THE MARYLAND-NATIONAL CAPITAL PARK & PLANNING COMMISSION

MEMORANDUM

REVIEW TYPE: Site Plan Review
APPLYING FOR: 3 one-family detached homes on 1.78 acres and 2 TDRs

PROJECT NAME: Kakar Property
CASE #: 8-04031
REVIEW BASIS: Site Plan required by the conditions of Preliminary Plan 1-03071
Site Plan required in the RE2-TDR2 Zone [§59-C-1.395 TDR Zone]

PROJECT DESCRIPTION: Proposal

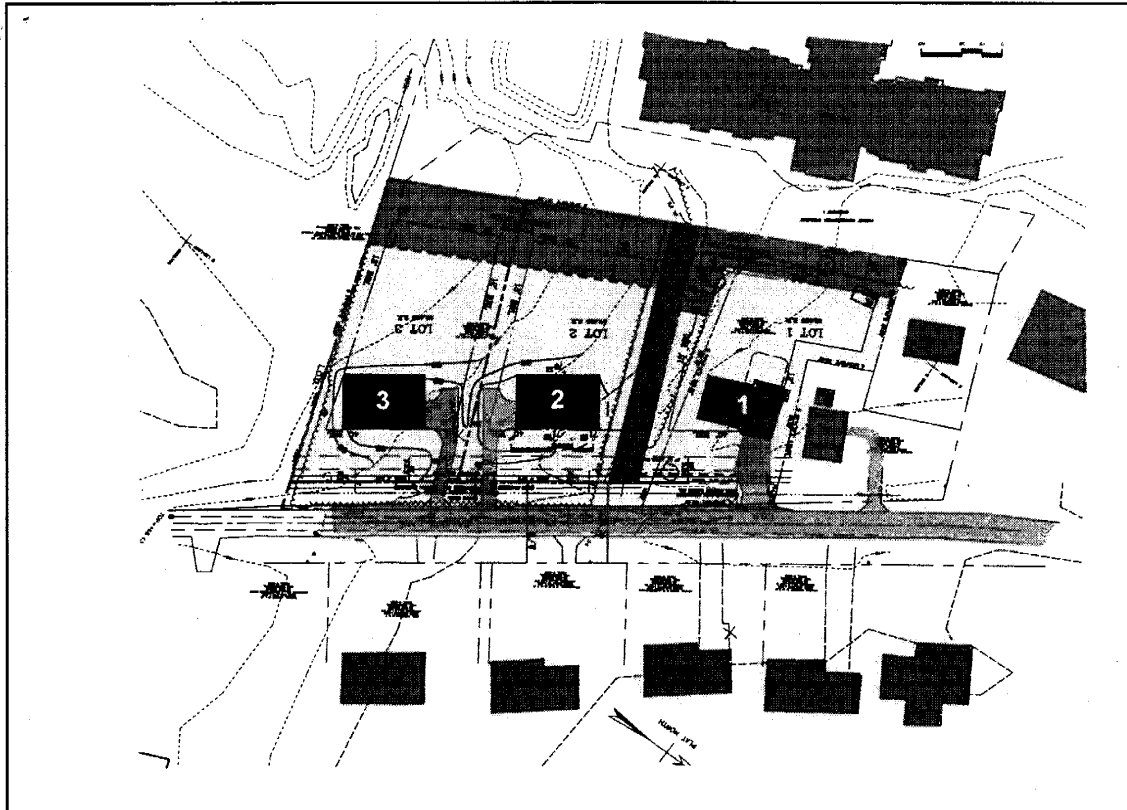
- a. Site Plan
Verify dimensions for the following: entrance drives, forest conservation areas, future rear decks; indicate clearly on the site plan the following: parcel boundary that includes Lots 1,2,and 3, lot lines with dimensions, limits of disturbance; final forest conservation boundaries.

- b. Landscape Plan
Provide landscape buffering to continue existing roadside wooded buffer using mixed evergreen, deciduous, and understory plantings in the following locations: from the side lot lines to the house edges, at the entrance drives, at the garages; location, plant spacing and species to be reviewed at signature set;

Open space provided consists of the front yards, rear yards, and a 50-foot wide forest conservation easement across the rear lot lines of the three properties. The proposed placement of the houses will provide shaded rear yards that are adequate, safe, and efficient. The generous rear yards create attractive open space while preserving attractive views of the forest conservation areas. Staff recommends that the signature set drawings indicate the form and location of any decks.

Landscaping for the project includes the provision of a forest conservation area across the rear of the three lots, along with various selected landscaping elements. Staff recommends strongly the following measures to ensure adequate compatibility: enhancing the visual boundary of the conservation easement by means of a split rail fence; extending the road side wooded buffer at the edges of the property to frame the houses and provide a visual connection to the existing wooded boundary. Staff also recommends selected landscape elements for screening the garages and driveways.

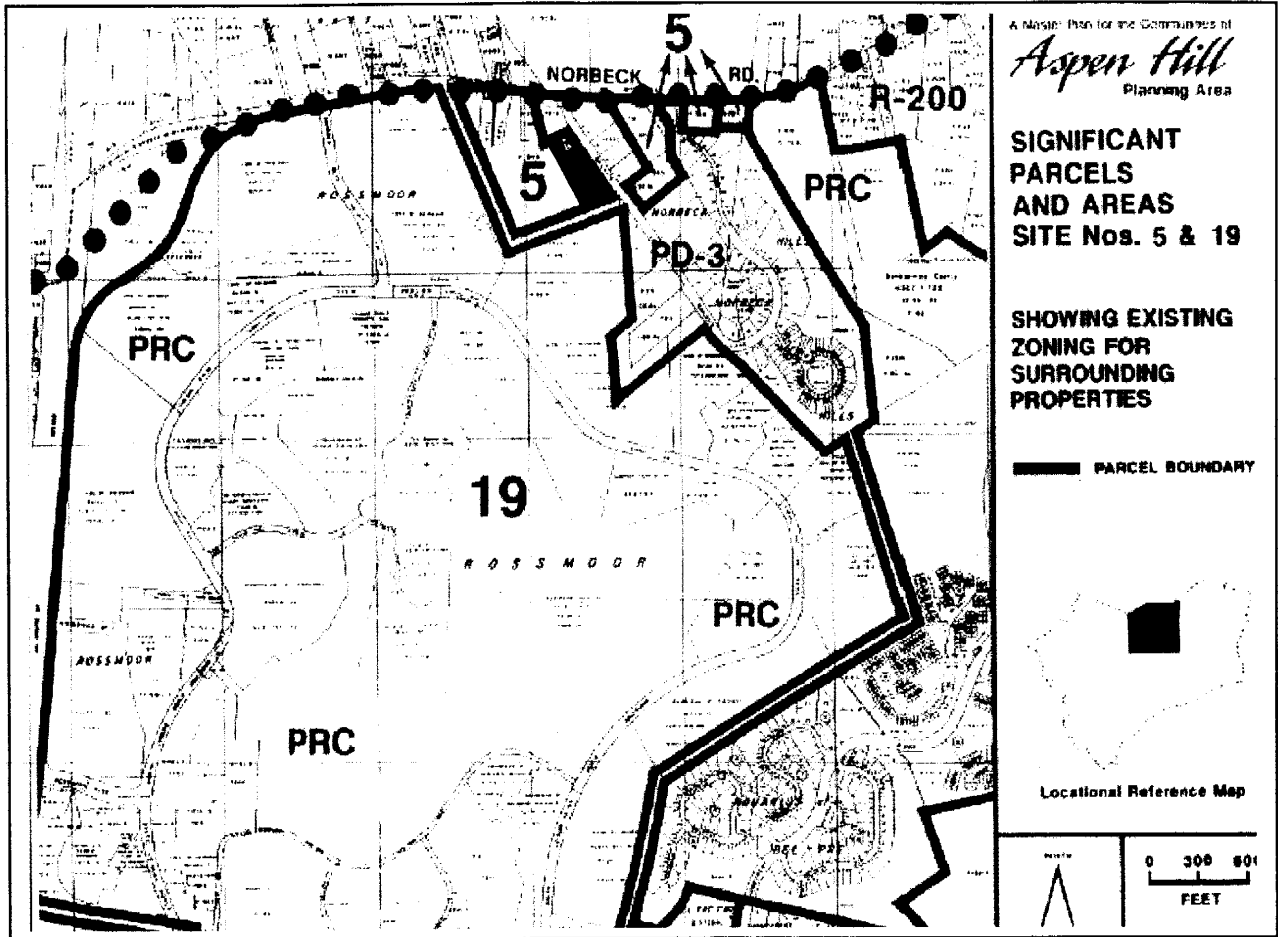
The Planning Board, in its Preliminary Plan deliberation, considered the issue of sidewalks, as applied to this open section lane with swales, and found that an on-site and off-site sidewalks requirement is "out of place" for this subdivision. The subsequent site plan application process reviewed the feasibility of sidewalks for the subject site's frontage, in response to the applicant's request for a waiver of such sidewalk. The Department of Permitting Services has reviewed the subject site with favorable inclination to a recommendation that a sidewalk within the street frontage is not necessary for the following reasons:

- Bailey's Lane is an open section macadam-surfaced road, with no curbs, gutters or sidewalks; the road terminates in a cul-de-sac with a loop road extension;
- The location of the drainage swales for storm water conveyance requires that any sidewalk be constructed outside of the right-of-way, on the subject property;
- The subject lots remain the only undeveloped parcels on Bailey's Lane; the other 24 houses were constructed before 1990;
- Relocation of the drainage swale and/or the installation of a curb and gutter system entails excessively costs;

The applicant has offered to agree to a covenant that would obligate the future property owners of the subject lots to participate on an equitable, pro-rata basis with other property owners to provide the sidewalk along the full length of Bailey's Lane.
